HIGH STRENGTH STEEL ANCHOR ROD PROBLEMS ON THE NEW BAY BRIDGE

Revision 1

November 12, 2013

**COMMITTEE ON TRANSPORTATION AND HOUSING
CALIFORNIA STATE SENATE**

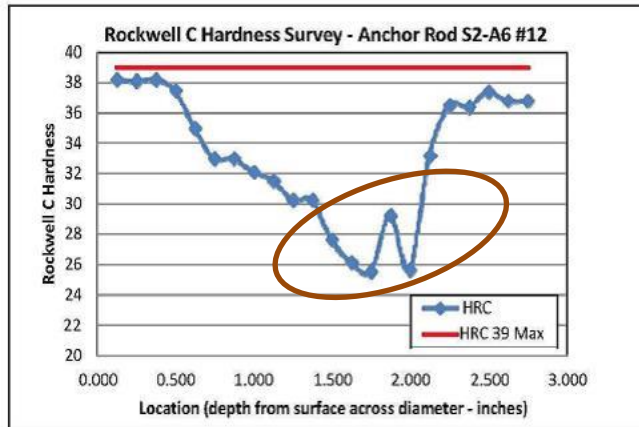
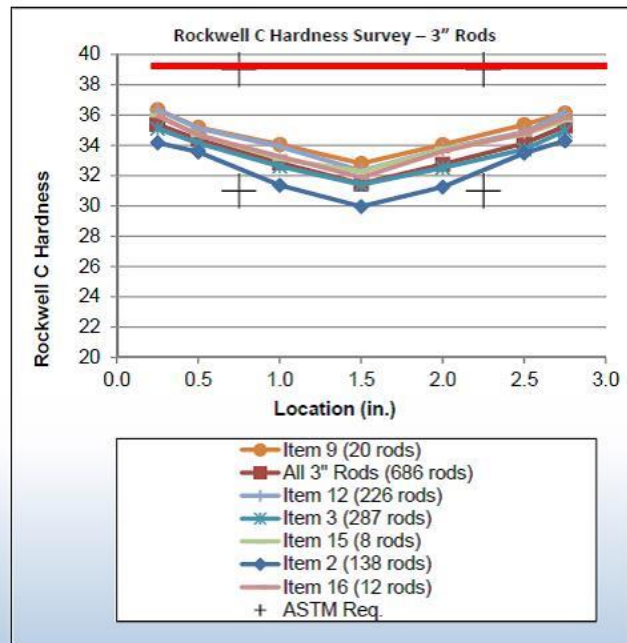
(1) The one on the left in Figure 9 is from a single rod that failed. It is not representative of "the 2008 bolts," but may represent one of the worst ones of the 32 rods that failed. It does not represent the

(2) The one on the right in Figure 9 represents average data of several lots of the "Other 3" Rods" that had highs and lows for individual rods. It is improper to compare the hardness traverse data of a single rod that failed against average hardness traverse data of a lot of many rods that did not fail. Therefore, Slide 23 may not be used as a support for "Improved Hardness" for the "Other 3" Rods."

Chung previously pointed out that some laboratory data in the ABC report need to be validated. For example, the data shown in Figure 9 (left) may have resulted from a specimen that was improperly prepared for hardness testing.⁵⁸ Specifically, the skewed hardness profile and the uneven appearance of the specimen surface may indicate that improper surface grinding of the specimen could have affected the hardness of the localized area. In spite of the potentially erroneous hardness data, the Caltrans Director used this particular hardness plot in Figure 9 (left) as one of significant findings.

Furthermore, the hardness traverse at left may have been obtained from a specimen that was improperly prepared. That is, “hard surface grinding” of the specimen surface may have tempered the local area, lowering the hardness to around 25.5 HRC from 30 HRC. Thus, the hardness data encircled may be erroneous.

Figure 10 Typical hardness traverse profile for low alloy steel, quenched and tempered. The HRC data are actual lab test data from a 3 inch round 4140 steel, quenched and tempered at 1025°F.

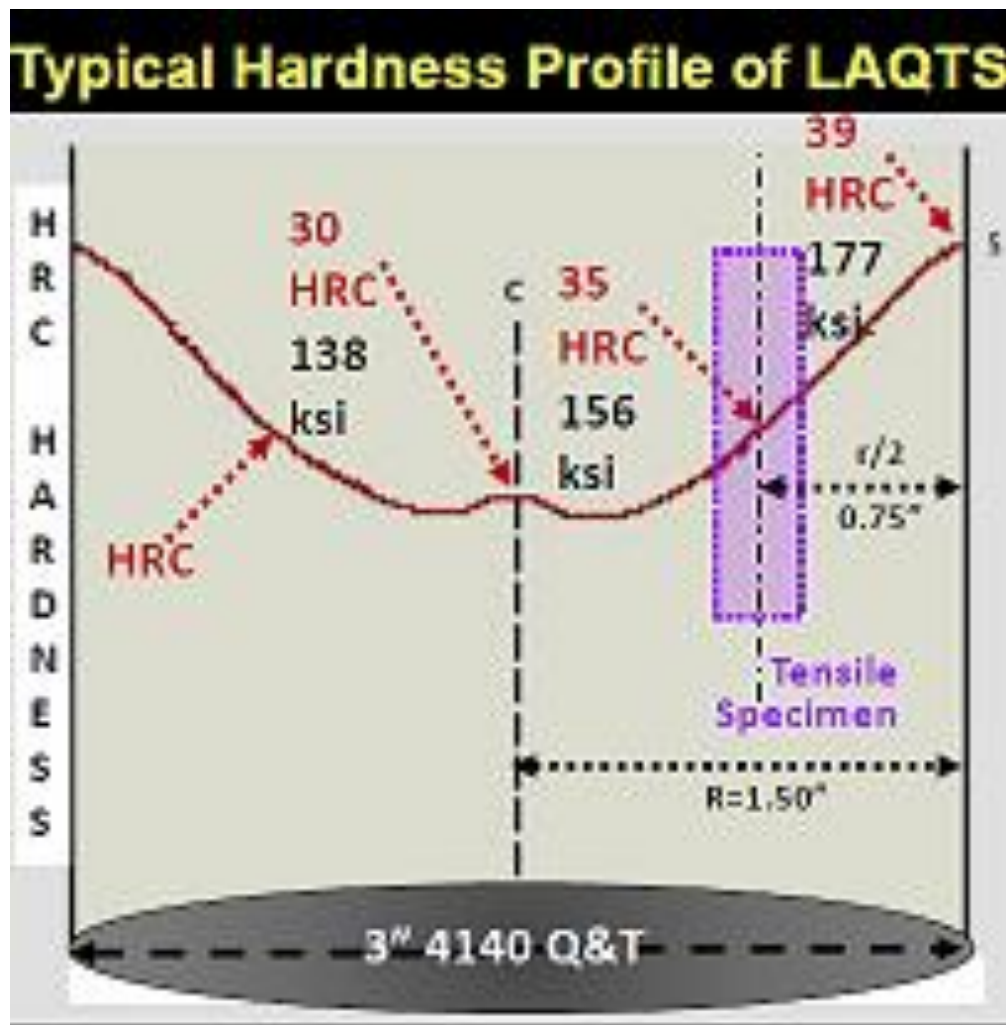
The HRC numbers cited in Figure 10 are actual lab test data from the ABC report. The hardness of a 3 inch anchor could vary from 39 HRC at the surface to 35 HRC at mid-radius (R/2) and to 30 HRC at the center (or core). The hardness decreases from the surface to the core as a result of different cooling rates that different locations would experience when the rod is hardened by quenching in an oil bath from around 1600°F. The larger the rod diameter, the slower the cooling rates, resulting in lower hardness.

The current hardness test protocol according to ASTM F606 is to take hardness readings at mid-radius or at R/2.⁸⁸ If the 31-35 HRC applies to the R/2 location, it would be still possible that the surface hardness may reach 39 HRC (Figure 10). This would be unacceptable in view of the failed S2 anchor rods had surface hardness of 36.2 – 36.8 HRC.

Figure 11 The three conditions for hydrogen embrittlement (HE) and stress corrosion cracking (SCC) (from the TBPOC report, p. 21).

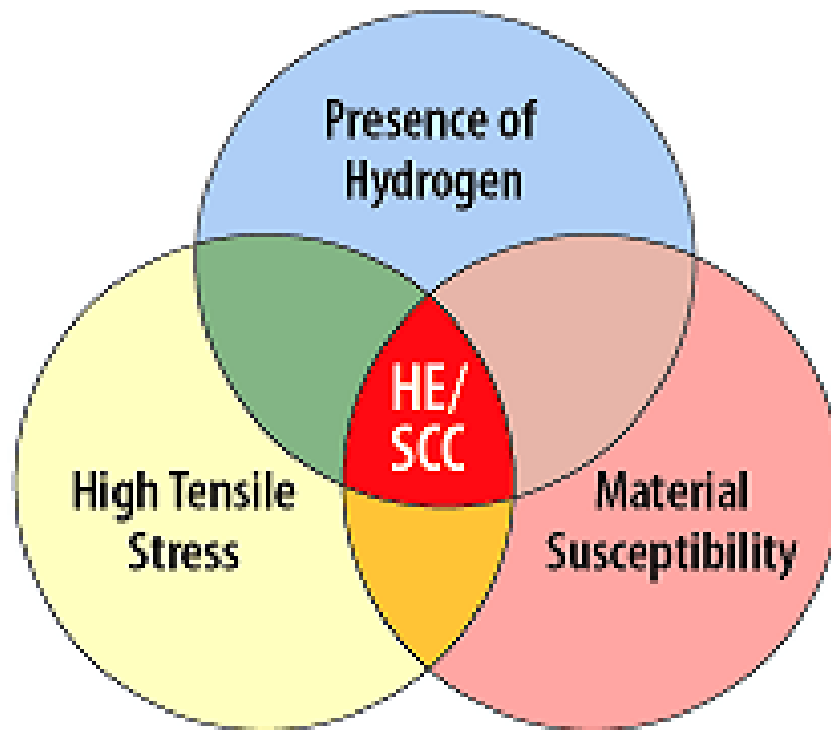
The above statement from the TBPOC report is erroneous because the susceptibility of a material to HE does not become “higher” when the material has met the three conditions. The “susceptibility to HE” remains the same. When the three conditions have been satisfied, the probability of HE failure would be “higher.”

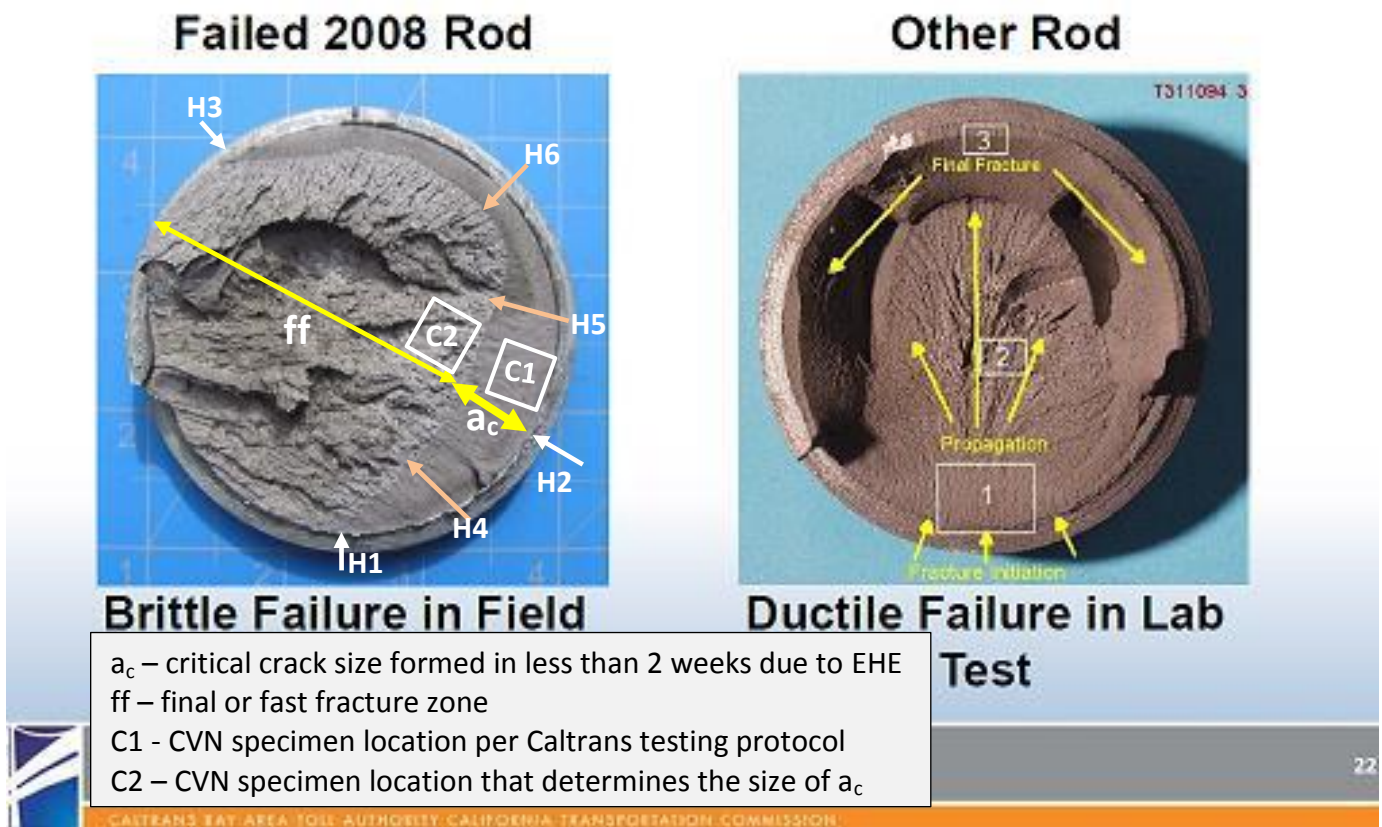
The only good part of the above statement is the last sentence. The rest is bad because it only reveals his and his staff’s ignorance about metal fractures and about why some rods fracture in a brittle manner while others in a ductile manner. They would not understand even a mild steel that would fracture in a ductile manner, for example with 30% or more elongation in a standard tensile test using a round cross section, could fracture in a brittle manner in the presence of a notch, like a pre-existing crack such as an HE crack in the “Failed 2008 Rod in Figure 12 (left).

- (1) Comparing a field failure due to HE with a lab tensile test failure is wrong; it is worse than comparing an apple to an orange. These fractures occurred under entirely different loading conditions.
- (2) The failed 2008 rod showed a brittle fracture more because of the notch effect of a pre-existing crack (or the hydrogen embrittlement crack, marked a_c in Figure 12 (left), that initiated along the thread root, marked by arrows H1-H2-H3, and grew gradually over several days), than because the steel had a poor microstructure, marginal ductility, or low toughness.

The smooth appearing HE crack zone, looking like a C in reverse, marked by arrows H1-H2-H3, encompassed about 60% of the thread root circumference. The tip of this crack at arrows H4-H5-H6 acted as a sharp notch that triggered the final fracture, ff, when the remaining intact cross section, marked ff, could not sustain the static stress in the rod. The effect of a notch on creating brittle fractures, particularly in thickness greater than about ½-inch in steels, is common knowledge among materials engineers. The notch effect of a single HE crack as a “stress intensifier” (Figure 12 (left)) is far greater than a series of thread roots during a lab tensile test in Figure 12 (right).

Conversely, the fracture face of the “Other Rod” that was labeled a “Ductile Failure in Lab Test” was produced under a monotonically rising load, in a matter of several minutes. About $\frac{3}{4}$ of this fracture, marked “1” and “2,” is macroscopically brittle, which is surrounded by shear lips, marked “3,” which are considered shear or ductile fractures, roughly at 45° with respect to the rod axis. So, the fracture face labeled “Ductile Failure in Lab Test” in Figure 12 consists roughly of 75% brittle fracture (1 and 2) and 25% ductile fracture (3), macroscopically. The difference in the fracture appearances in Figure 12 is really not a “big deal” at all or “significant” to talk about at a presentation.

(3) If a “2008 rod” without the HE crack was broken in a lab tensile test under a monotonically rising load as was done for the “other rod,” the former would have fractured just like that of the “Other Rod” in Figure 12 (right). Only the size of the shear lips could vary, depending on the ductility; but basically will be not much different.

(4) Conversely, if one of the “Other Rods” had failed due to hydrogen embrittlement (IHE or EHE), the fracture face would have looked like that of the “Failed 2008 Rod” in Figure 12 (left). Only the size of the smooth fracture zone (or the HE zone along the thread root at arrows H1-H2-H3) could vary depending on the toughness of the steel and stress; but basically will be not much different.

(5) If the three upward yellow arrows from “2” to “3” and the two downward yellow arrows from “3” in the fracture face of the “Other Rod” in Figure 12 (right) were meant to indicate the fracture propagation directions, the top two yellow arrows from “3” are wrong. The shear lip at “3” would not propagate as indicated by the top two yellow arrows. No shear lips in tensile specimen fracture faces will propagate as indicated by the two top yellow arrows. The top two yellow arrows from “3” would indicate that the shear lip fracture at the top of the picture originated at “3” and propagated across “sharp steps,” forming a jog and propagated downward. This will not happen and the yellow arrows from “3” are wrong.

Referring to Figure 12 (left), Caltrans testing protocols call for a CVN test specimen location at C1, from the surface layer as close to the rod surface as possible. What controls the critical crack size, a_c , in Figure 12 (left) would be the toughness at C2, at the end of the HE crack zone that initiated at a thread root and has grown over a period of several days after the rod was pretensioned. Since a 3 inch 4140 steel rod will have a bowl shaped hardness curve across the diameter, like Figure 10, when quenched and tempered in accordance with the heat treatment requirement of ASTM A354, Grade BD, C2 will have different CVN values from those at C1. Therefore, the CVN values at C1 as a rod production control or a procurement specification requirement would be useless in “buying” the time once microscopic HE cracks have formed at a thread root. Also, it would be futile to specify other locations than C1 for CVN testing for the same purpose.

If the a_c in Figure 12 (left) reached about $R/2$ (mid-radius) in less than two weeks after the rod was pretensioned, it would have taken only another two weeks or so for this crack to advance to $D/2$ (center), at which point what CVN values might have been specified for the surface layer would have made no difference. So, the difference between a low toughness rod and a high toughness rod would be only a matter of weeks of the “time to failure” after pretensioning. That is not of much benefit.

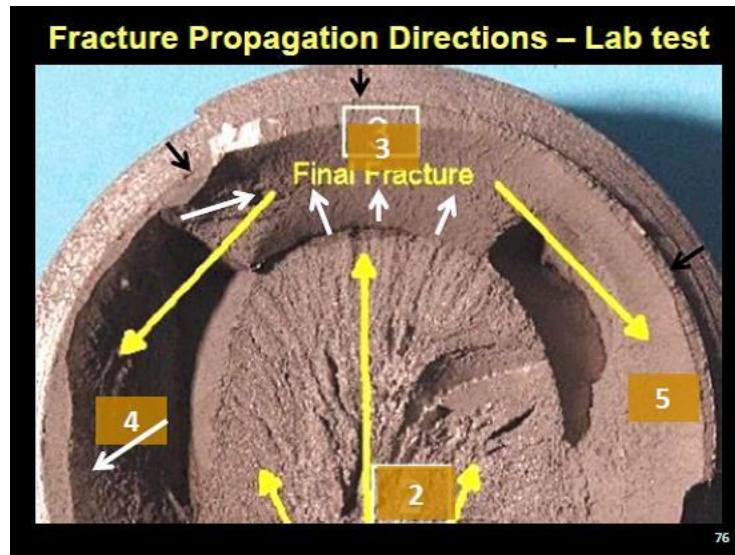
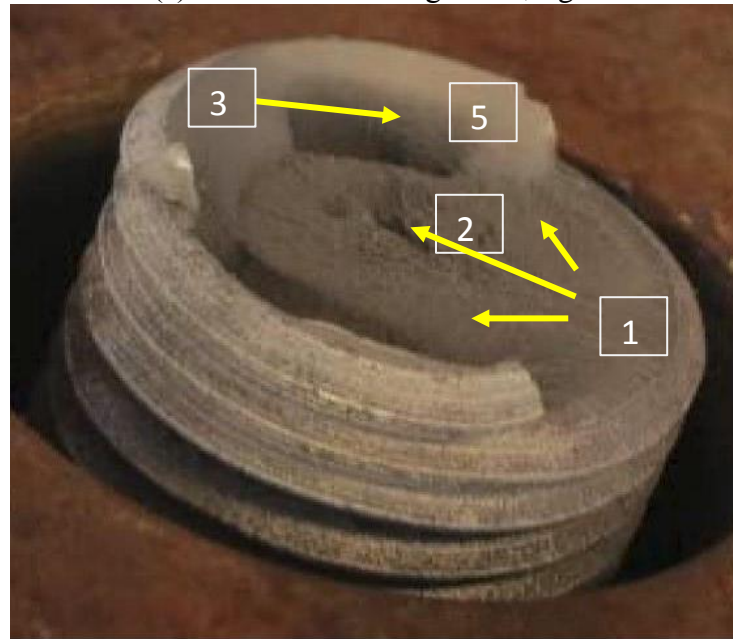
Instead, the white arrows in Figure 13a indicate probable fracture propagation directions in the shear lips, including that for the shear lip at “3.” The black arrows point to a narrow flat fracture band along the thread root that intersected the shear lips. Figure 13b shows a perspective view of the same fracture face as that in Figures 12 (right) and 13a. Figure 13b is from File E17.⁶⁴ Figures 13a and 13b clearly show why “3” could not have acted as a fracture origin for the shear lip and the shear fracture could not have propagated toward “5” across the sharp step. The same is true for the left yellow arrow from “3.”

The black arrows point to a narrow flat fracture band along the thread root, which is not part of the shear lip, marked 3, 4, and 5. The white arrows point to the direction of crack propagation in the shear lip.

(b) The fracture face of the same specimen as in (a) from File E17,¹⁰⁴ showing that the fracture propagation from 3 to 5 cannot occur as indicated by the top yellow arrow.

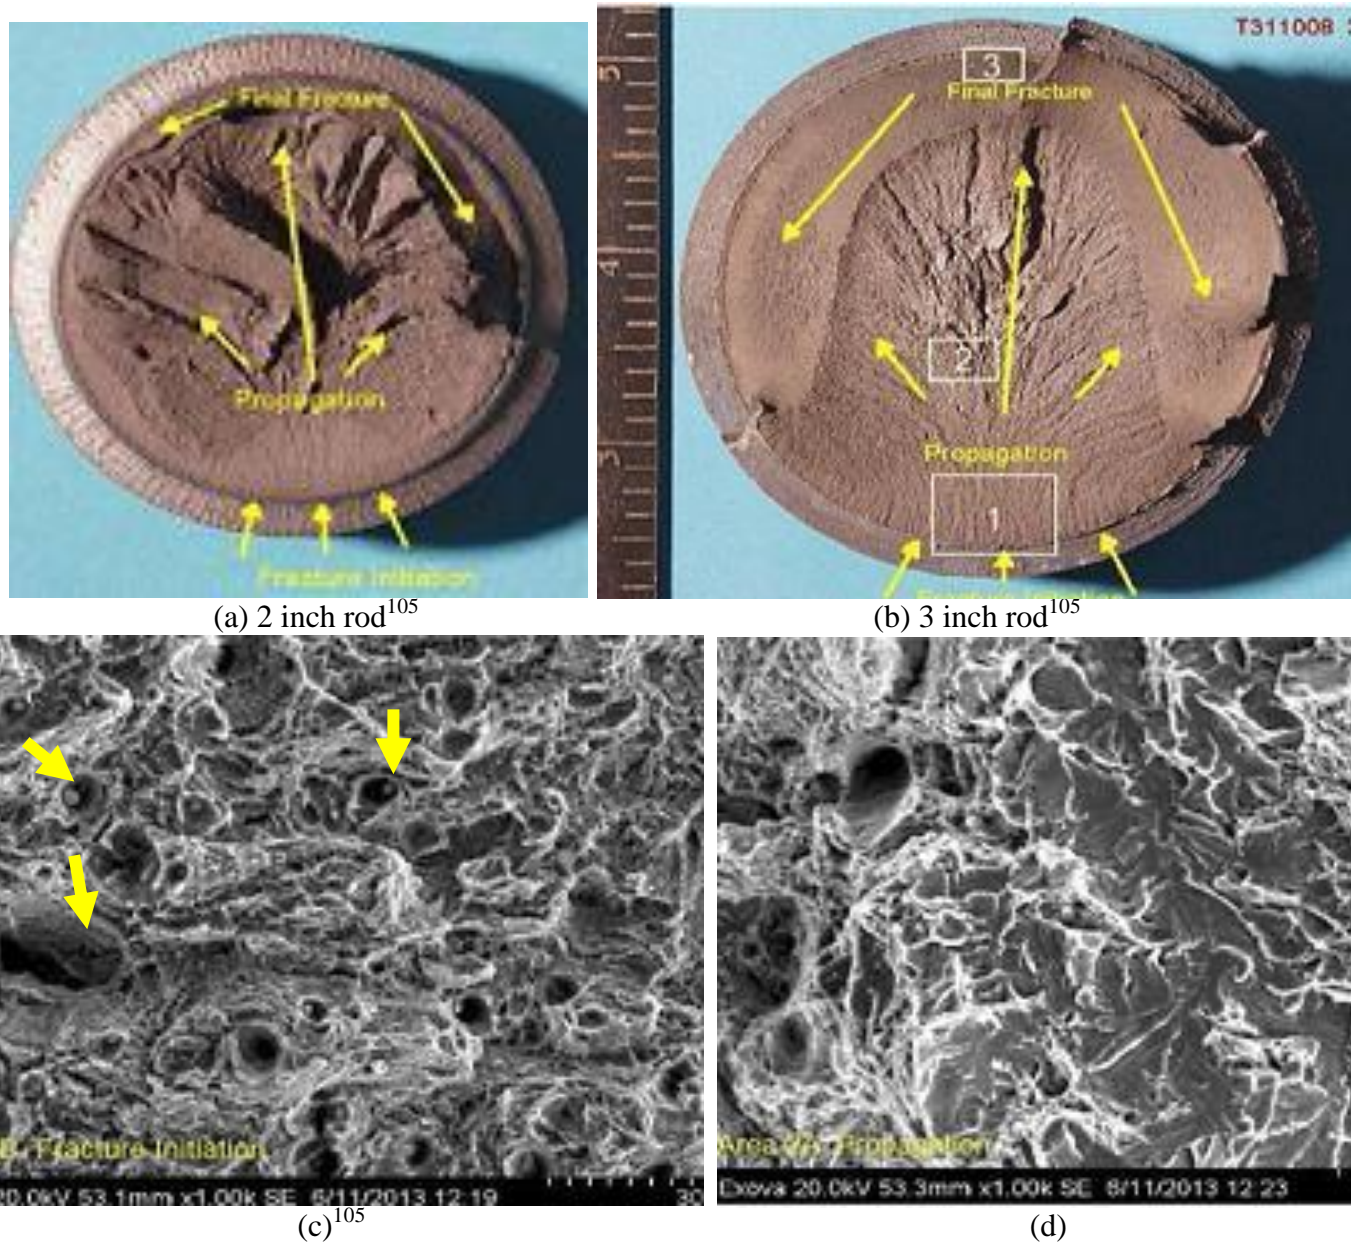
Figures 14a and 14b show a 2 inch and a 3-inch diameter ASTM A354 Grade BD anchor rods, respectively. They were tensile tested in full size by Caltrans.⁶⁵ Again, the top two yellow arrows were marked incorrectly as crack propagation direction indicators. In addition, the long upward yellow arrow along the diameter in Figure 14a does not really do the job because the fracture propagation directions in this region are quite complex as indicated by various valleys and ridges in the top two-thirds of the fracture face. A fracture path will not be continuous across ridges or valleys.

Figure 14c is a scanning electron fractograph from area “1” in Figure 14b. Macroscopically, the fracture face at “1” is brittle in Figure 14b; it is flat and without signs of plastic deformation such as stretching,

elongating, or distorting. Microscopically, however, the area “1” in Figure 14b consists entirely of dimpled fractures, which are a ductile fracture mode microscopically, as shown in Figure 14c. The “large” holes in Figure 14c form usually around nonmetallic inclusions, or some other second phase particles, such as those marked by the yellow arrows. They are seldom referred to as a “cup and cone,” as used in the caption of this and other fractographs in File E17. Firstly, they are all “cups” without “cones.” Secondly, the “cup and cone” description applies to the macroscopic appearance of ductile fractures with shear lips of machined round tensile test specimens and not to the holes (or “cups”) in scanning electron fractographs of dimpled fractures under high magnifications.

The scanning electron fractograph in Figure 14d from area “2” in Figure 14b consists of about 50:50 dimpled and cleavage fractures. Although area “2” is macroscopically brittle, it is not entirely brittle microscopically. Thus, what is brittle and what is ductile is sometimes difficult to define. A distinction between them may be unclear whether in terms of a microscopic scale or a macroscopic scale. It may even be meaningless as used in the “Mode of Fracture” in Table 13 of the TBPOC report,⁶⁶ to be discussed in 2.16.

⁶⁷ The caption of the scanning electron fractograph, reproduced in Figure 14c, was also wrong.

“Dimples” are not known as or described as “cup and cone features.” The former is a fracture mode description in a microscopic scale and the latter in a macroscopic scale.

Figure 15

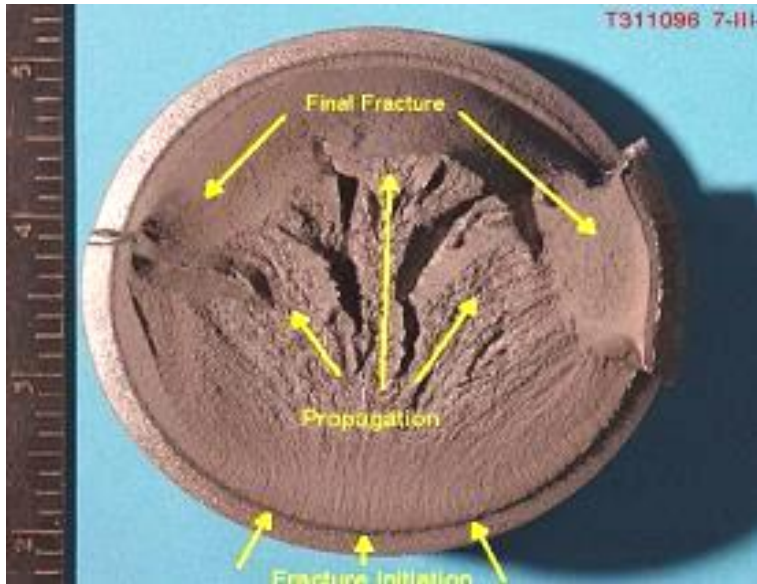
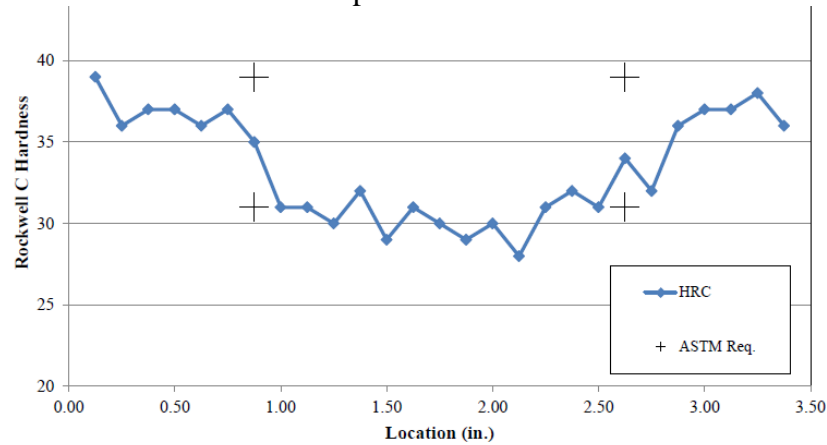
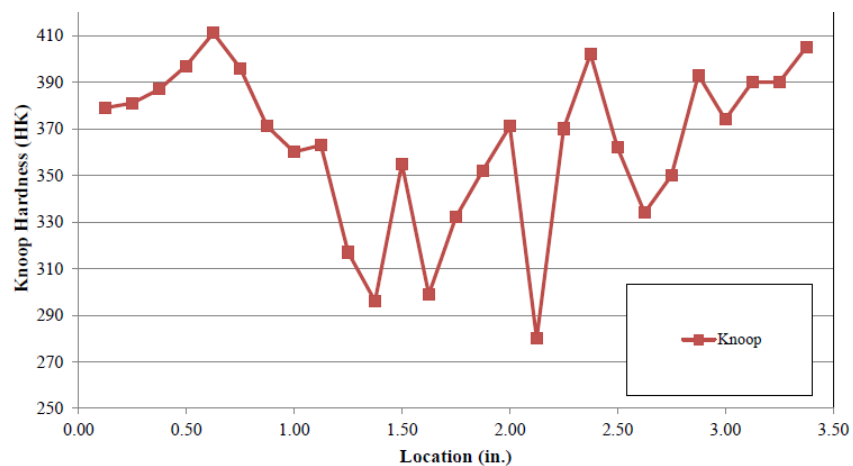
The fracture face of a PWS anchor rod sample in Figure 15a shows no indications of the effect of cold working around the thread root. The hardness traverse data in Figures 15b and 15c also have no indications of the effects of the increased hardness at thread roots.⁹² This is probably because the sample rods for a full size tensile test, hardness test, metallographic and SEM evaluation, CVN test, and chemical analyses of the steel and the zinc coating were selected at random without specific purpose of determining the cold work effects of the rolled threads.

⁹² File E17 contains many HK hardness traverse data like that in Figure 15c. None of the HK data had the applied test force used, as recommended for HK data presentation by ASTM E384, para. 5.8.1.

(a) The fracture face of a full size PWS (Parallel Wire Strands - main cable) anchor rod tensile test specimen. The top two yellow arrows are wrong.

(b) & (c) HRC and HK hardness traverse curves for PWS anchor rod specimens. (No load was given for the Knoop microhardness data.)

The fracture appearance as well as the HK data in (c) indicate this was not one the 219 PWS anchor rods with rolled threads.
